Office Action Summary	Application No.	Applicant(s)	
	10/565,292	BAROUTA, TONY	
	Examiner	Art Unit	
	Nkeisha J. Dumas, Esq.	3632

1. The following correspondence is a non-final Office Action for application number 10/565,292 for a DEVICE FOR RELEASABLE MOUNTING OF A BUNDLE OF BAGS ON A WALL, filed on 1/20/2006. Claims 1-6 are pending.

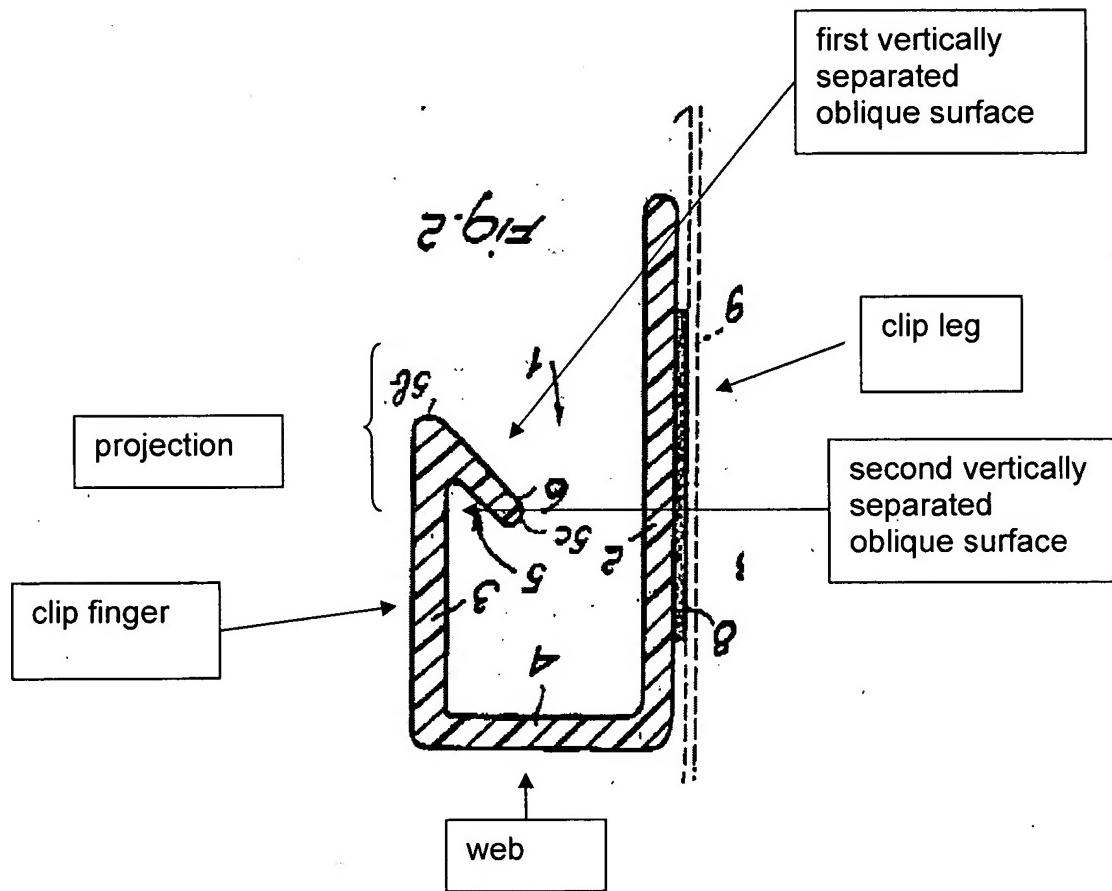
Regarding claim 1, Moreno teaches a device (1) comprising a wall-mounted suspension fitting (Fig. 2) in that the fitting has an upwardly directed clip finger (3) which

includes a projection having two vertically separated oblique surfaces which are mutually convergent in a direction towards the wall (see figure below as rotated).
